## Service Bulletin

**Title:** AIR CONDITIONING – Condenser Inlet Duct and Tail Rotor Drive Shaft Inspection.

**Summary:** This Service Bulletin requires immediate inspection of the tail rotor drive shaft below the condenser air inlet duct assembly before next flight.

**Effectivity:** Airbus Helicopter Deutschland GmbH (AHD) models MBB-BK 117 C-1 & C-2 with installed Air Comm Corporation air-conditioning system with the air ducts/fairing cutouts to the condenser.

**Figure 2 – Tail Rotor Drive Shaft and Duct Installation**

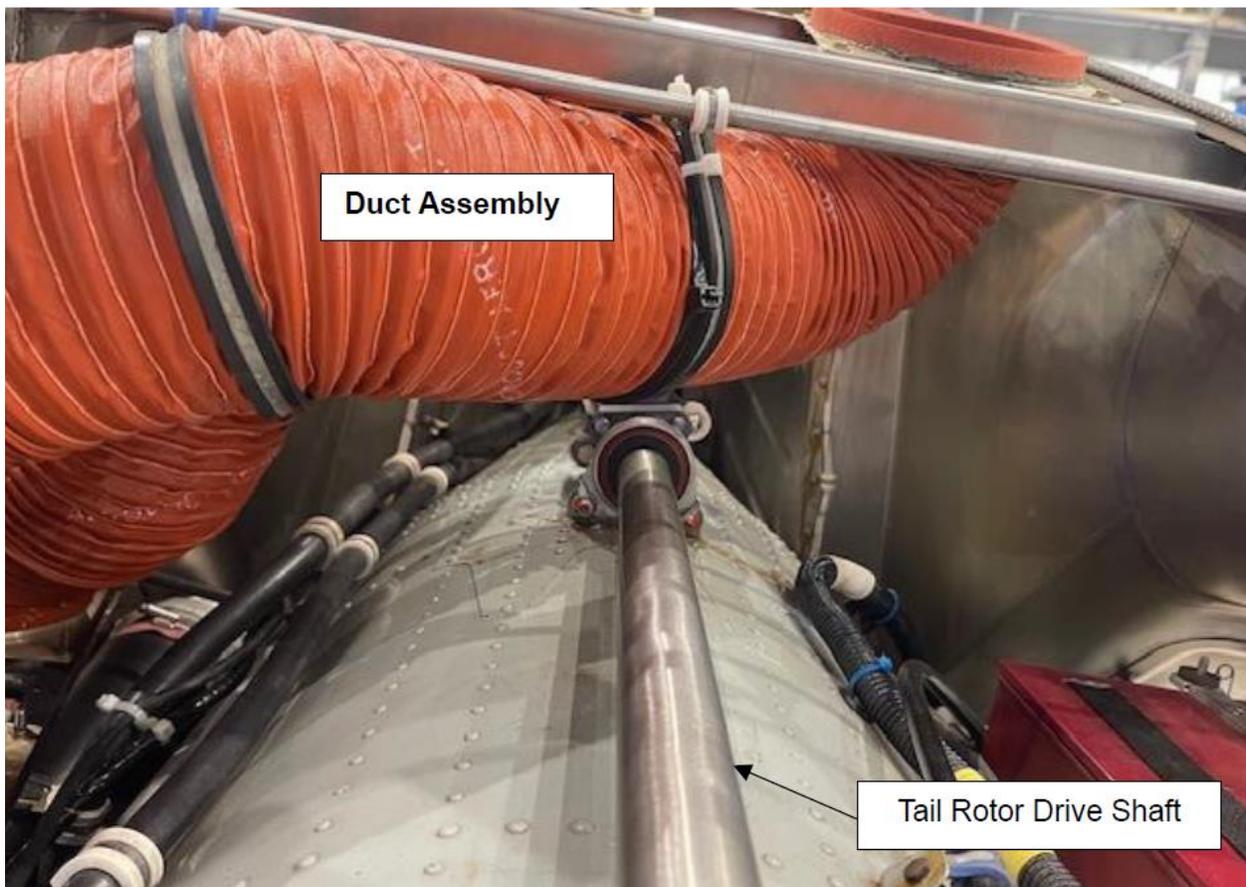
1. Follow the aircraft AMM instructions and gain access to and inspect the tail rotor drive shaft in the location below the ACC condenser air inlet duct assembly.

Figure 3 – Typical Damage

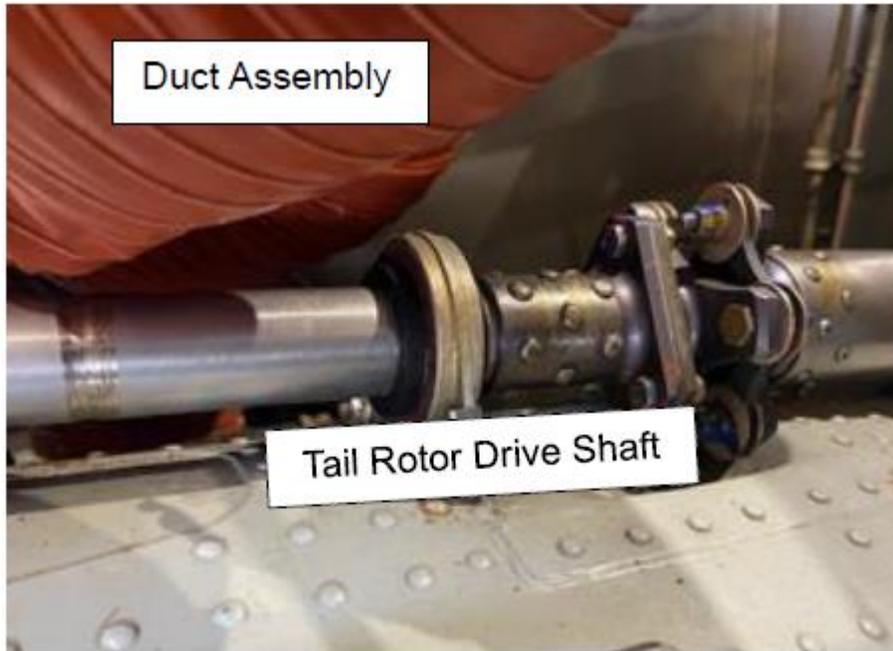
ACC has been made aware of multiple aircraft where excessive corrosion of the condenser inlet duct has allowed the internal support wire helix to break and protrude from the duct silicone shell and then impinging on the tail rotor drive shaft. In one instance, the tail rotor drive shaft was significantly compromised. It has also been noted on some installations that the duct support clamp was not aligned to the drawing representative position that would maximize the clearances.

2. Inspect the installation and condition of the ACC condenser air inlet duct assembly p/n EC145-7040-1.
  - a. Inspect the duct exterior condition. If any of the duct helix wire has broken and is protruding into or out of the silicone shell, then replace the duct assembly p/n EC145-7040-1 with a new assembly. Use the Figures in this document for the installation views, component orientation and required hardware.

**Figure 8** – Clamp Orientation Comparison

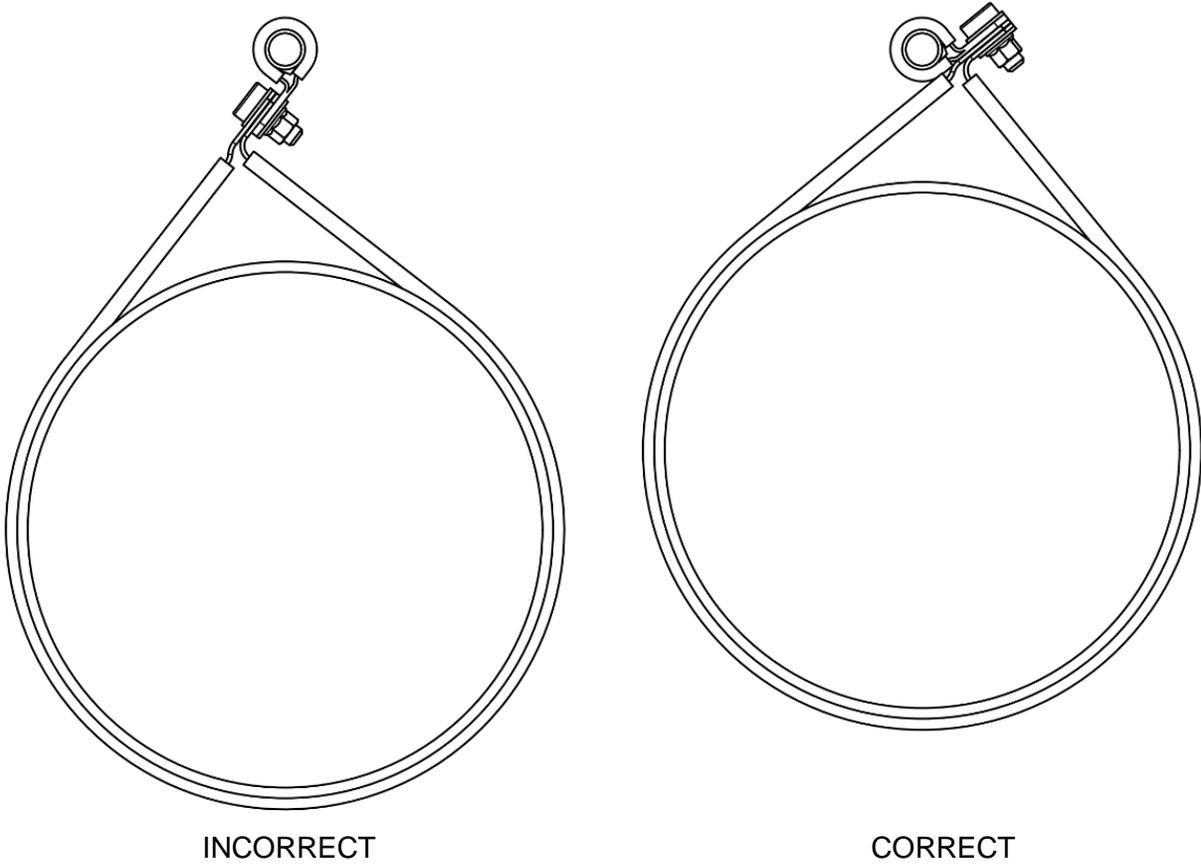
- c. Inspect the exterior clamp positioning. If it does not match the drawing Figures, in this document then rearrange the clamp to raise the duct positioning. Maintain a downward slope to the duct.
